# 625 SINGLE TOUCH LEVELING SYSTEM PIGTAIL UPDATE FOR SYSTEMS WITH REMOTE ROCKER SWITCHES

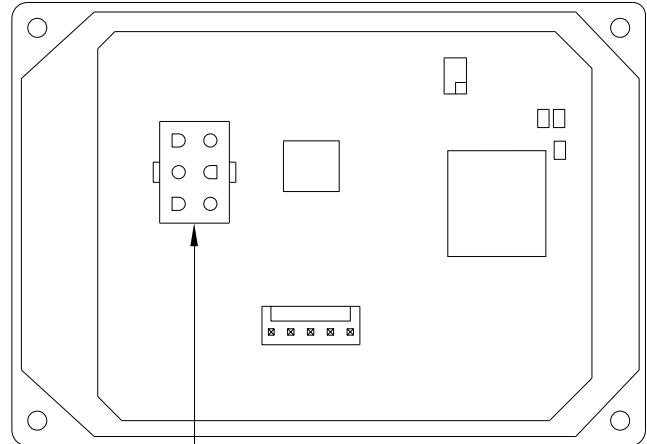
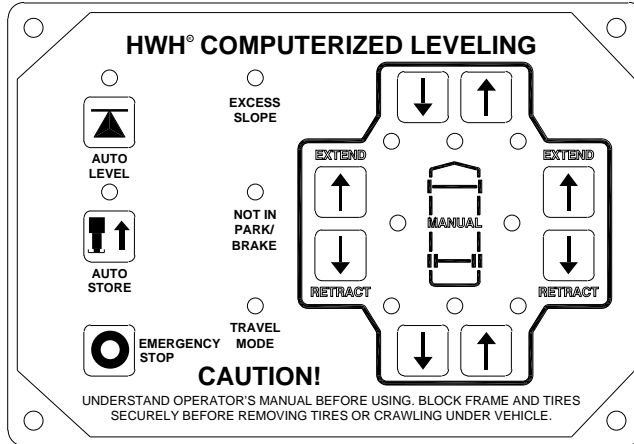
**NOTE: ONE TOUCH LEVELING SYSTEMS WITH REMOTE ROCKER SWITCHES MAY EXPERIENCE THE LEVELING SYSTEM SHUTTING OFF DURING AN AUTO LEVEL OR STORE SEQUENCE. THE ADDITION OF THIS PIGTAIL WILL UPDATE THE SYSTEM TO RECTIFY THIS ISSUE.**

UNPLUG EXISTING HARNESS AND INSERT PIGTAIL BETWEEN TOUCH PANEL END EXISTING HARNESS.
